PLAN COMMISSION PC #22-015
Holladay Properties Self Storage
401 W Golf Road
Round 2

Project: Holladay Properties Self-Storage
397-401 W. Golf Rd.

Case Number: PC 22-015

VILLAGE OF ARLINGTON HEIGHTS WATER METER PIT SPECIFICATIONS

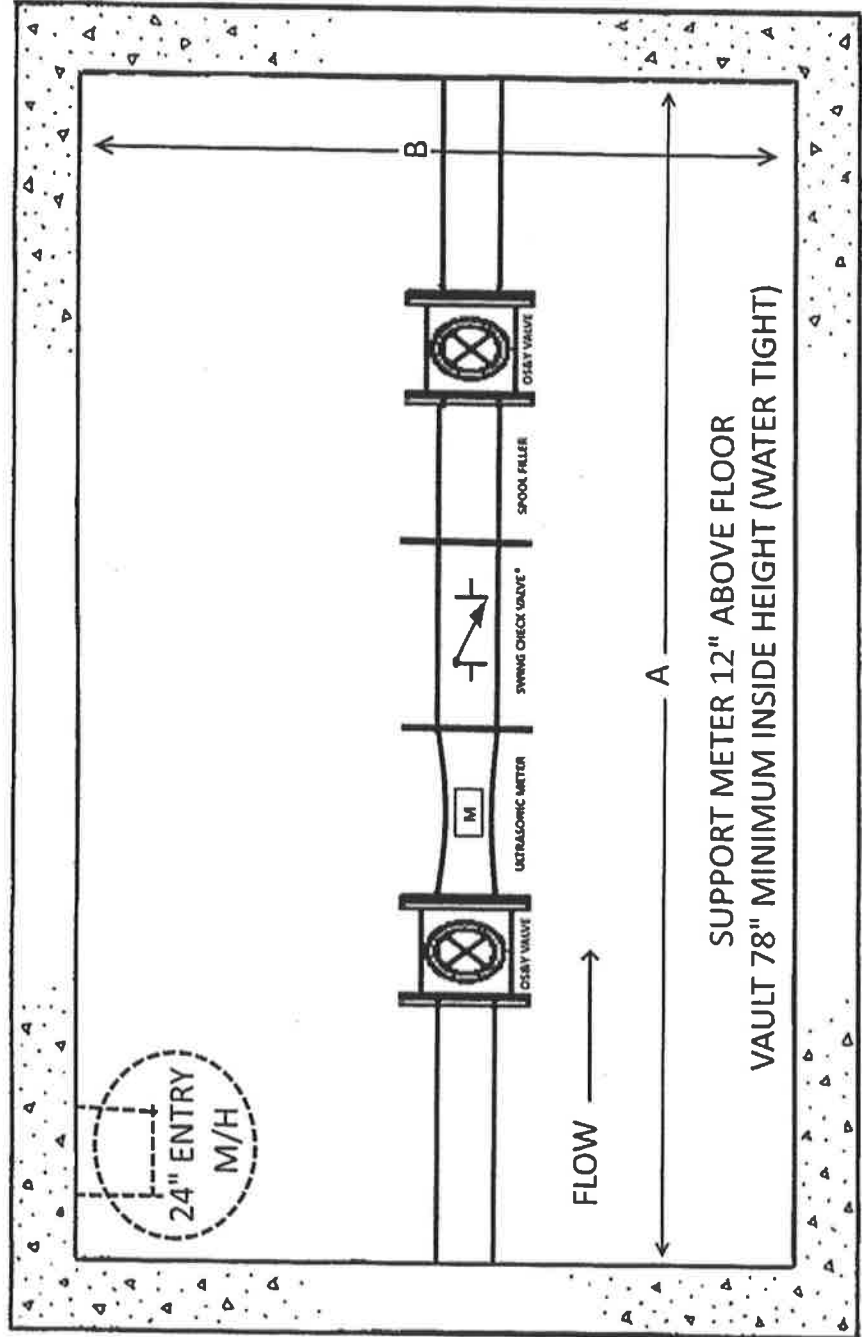
- 39. Install the new meter pit with new valves on the existing 6" service line to the fire hydrant.
- 40. Remove the old check valve in the existing vault.
- 41. Use the attached diagram for the fire line meter pit.
